## DEVELOPMENT APPLICATION ASSESSMENT REPORT

<b>Application Number:</b>	DA2025/0117
----------------------------	-------------

<b>Responsible Officer:</b>	Adriana Bramley
<b>Land to be developed (Address):</b>	Lot 7 DP 224946, 12 Molong Street NORTH CURL CURL NSW 2099
<b>Proposed Development:</b>	Demolition works and construction of a dwelling house including a swimming pool and cabana
<b>Zoning:</b>	Warringah LEP2011 - Land zoned R2 Low Density Residential
<b>Development Permissible:</b>	Yes
<b>Existing Use Rights:</b>	No
<b>Consent Authority:</b>	Northern Beaches Council
<b>Land and Environment Court Action:</b>	No
<b>Applicant:</b>	Emma Brooke Lambert

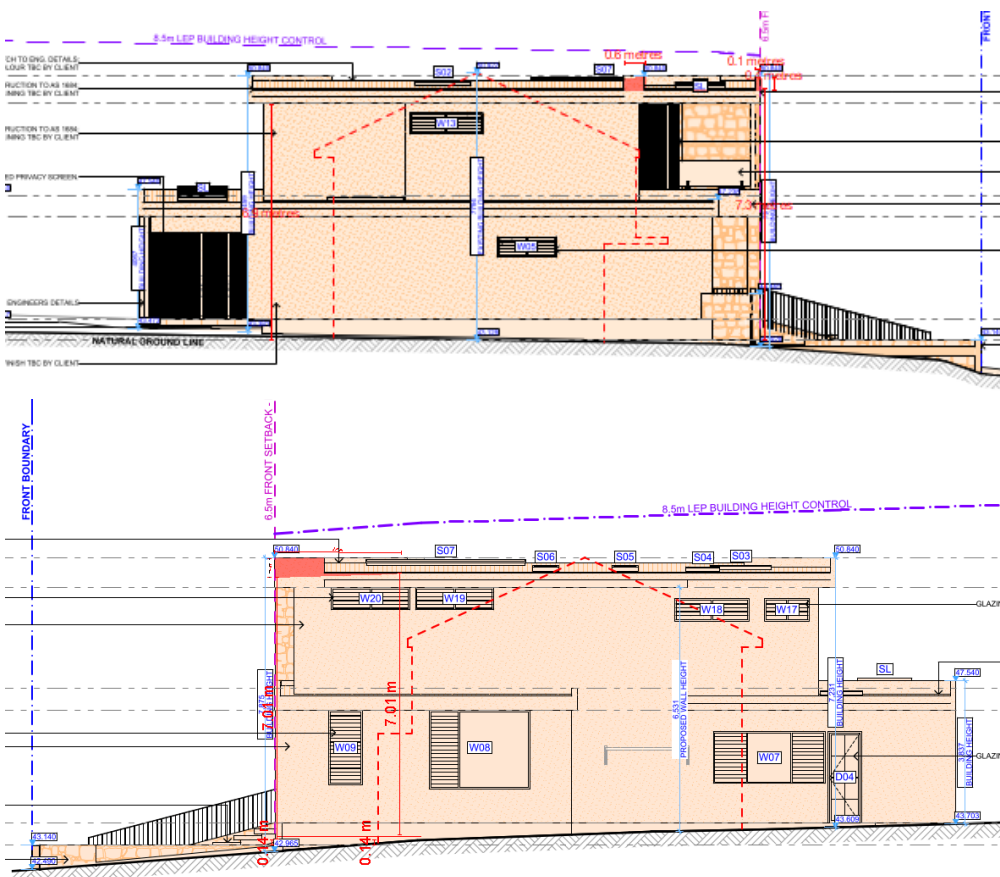
### **B3 Side Boundary Envelope**

#### Description of non-compliance

Areas of non-compliance are shown in RED as follows:

- Western Elevation - small sections of parapet (measuring 0.1m x 0.4m and 0.6m x 0.4m)
- Eastern Elevation - section of parapet and upper wall (measuring up to 0.5m for a length of 3.4 metres)
- Both non-compliances are evident from the Southern Molong Street Elevation.

proposal is supported, in this particular circumstance.
